IN THE DRAWINGS:

REMARKS

This Amendment is submitted in response to the Final Rejection dated March 14, 2006 and the Notice of Non-Compliant Amendment dated June 29, 2006. In the March 14, 2006 Office Action, the Patent Office requires Applicant to provide information under 37 CFR §1.105 which the Patent Office has determined is reasonably necessary to the examination of the application. Additionally, the Patent Office refused to consider an Information Disclosure Statement (hereinafter "the IDS") filed on January 3, 2006 and asserts that the IDS fails to comply with 37 CFR 1.98(a)(2). Further, the Patent Office objected to the drawings under 37 CFR §1.84(p)(5) because the drawings include a reference character not mentioned in the description. Still further, the Patent Office objected to the drawings under 37 CFR §1.83(a) for failing to show every feature of the invention specified in the claims.

FIG. 8

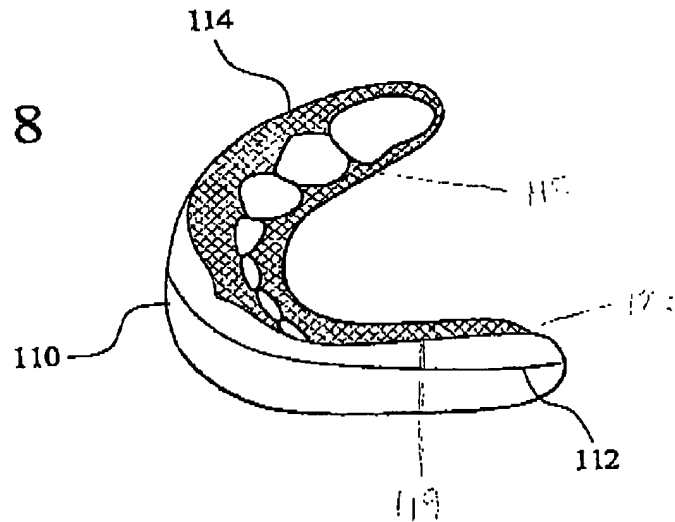
Further, the Patent Office objected to the drawings under 37 CFR §1.84(p)(5) for failing to include reference signs 115, 117, 119 and 121 which are mentioned in the description. In response to the objection, Applicant amended FIGS. 8 and 9 to show the lingual shields 115, 117 and the buccal shields 119, 121 as set forth on page 22 of the description. Applicant also amended FIGS. 8 and 9 to show the rear portion 123 of the upper shell 110 and the rear portion of the lower shell 120.

FIG. 8 has been corrected as shown in the Replacement Drawing Sheet and as shown in red in the Annotated Sheet Showing Changes in the attached Appendix.

The lingual shields 115, 117, the buccal shields 119, 121 and rear portions 123, 125 are disclosed in the specification as filed. Specifically, page 22, lines 2-5 state: "The upper shell 110 and/or the lower shell 120 may have roughened, or coarse surfaces 114, 122, respectively, along the lingual shields 115, 117 and/or buccal shields 119, 121 to secure the relined material 132." Further, page 22, lines 8-10 state: "The lingual shields 115, 117 and the buccal shields 119, 121 may have a mark 112 placed on the roughened
